RE: Potential Change Order 0177
Collin County Justice Center - 3090

Hunt Construction Group (Hunt) respectfully requests your review and approval of the attached Potential Change Order (PCO) number **0177** as titled: **Install Gypsum Board Smoke Curtain per RFIs 176 & 440**. This change is required to provide a complete smoke control system as was intended for this project. Cost to complete the work is as follows:

Request for Information 440

Request for Information 176

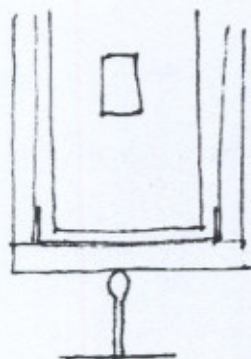
Ref. M2.23 & RFI 176:

M2.23 shows a 60"x24" damper in the plenum space above Atrium 20066 along column line 'E'. RFI 176 calls for the damper to be located in a 'partition' which is not required to be fire or smoke rated.

1. Per earlier telephone conversation between John Reese, Bryant Hand, and Landry Ray, please confirm the 'partition' shall stop at the top of the tees when passing over grid ceiling (ref. attached sketch).
2. Please indicate which partition type shall govern for construction of this curtain (i.e. stud size & gypsum board thickness, etc).

2. Hunt request consideration be given to using partition type 2A (5/8" drywall on both sides of 3 5/8" metal studs) with no acoustical caulk at head or base.

1. The plenum partition shall stop at the top of the ceiling grid as shown on your original sketch (attached) so that it is directly above a continuous T member in order to restrict airflow between the partition and the ceiling.

2. The partition may be constructed using construction similar to partition type 4A since gypsum board is only required on one side to stop air movement. The use of either 2 1/2" or 3 5/8" metal framing by the Contractor is acceptable to the Architect. The purpose of the partition is to limit air movement in the Atrium plenum when the building is in the smoke exhaust mode. The Contractor is responsible for drywall partition design per the specifications. The bottom of the partition shall have a layer of gypsum board between the track and the top of the T as shown in your sketch. The partition does not need to be rated. Sealant at the top of the wall will not be required if the top of the wall is held tight to the structural deck and beams/joists. The partition shall have a Level 1 finish.

3. We have included our response to RFI 176 (which you attached to this RFI) without any change.
